# AGENDA CITY OF STURGEON BAY CITY PLAN COMMISSION

Wednesday, December 20, 2017 6:00 p.m. Council Chambers, City Hall 421 Michigan Street

Consideration of Conceptual PUD for Bonovich Properties, LLC

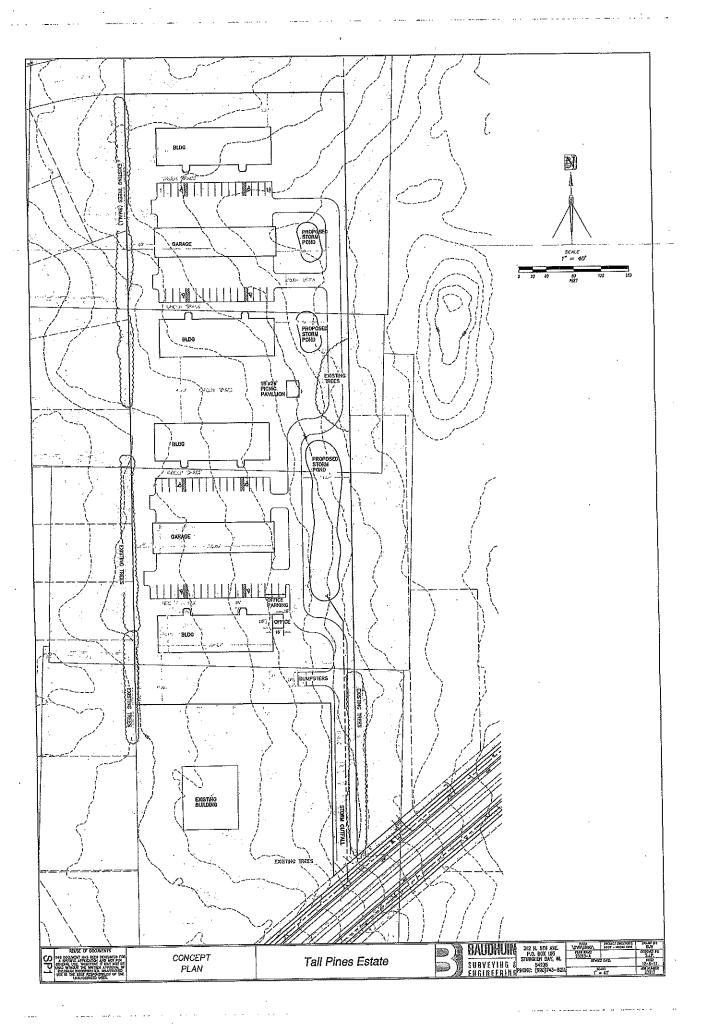
In the process of reviewing the conceptual plan, a few items were found that should be considered.

- 1. The City has a plan to extend Alabama Place to North 12<sup>TH</sup> Place along the north property line of the subject property. In case the City plans on extending this road, should an agreement be made to connect the driveway to Alabama Place? The City and developer should consider the impact of the potential street extension when discussing architecture and road access.
- 2. The next notable item is signage. If there is intent to place a sign at the driveway adjacent to Egg Harbor Road, the PUD will need to address that due to the inability to meet the interior lot line setback for the sign.
- 3. A preliminary Certified Survey Map (CSM) has been submitted for the division of the subject property. The CSM's approval is subject to the approval of the PUD because the flag shaped lot does not meet lot width requirement under Chapter 27 Subdivision and Platting Code.
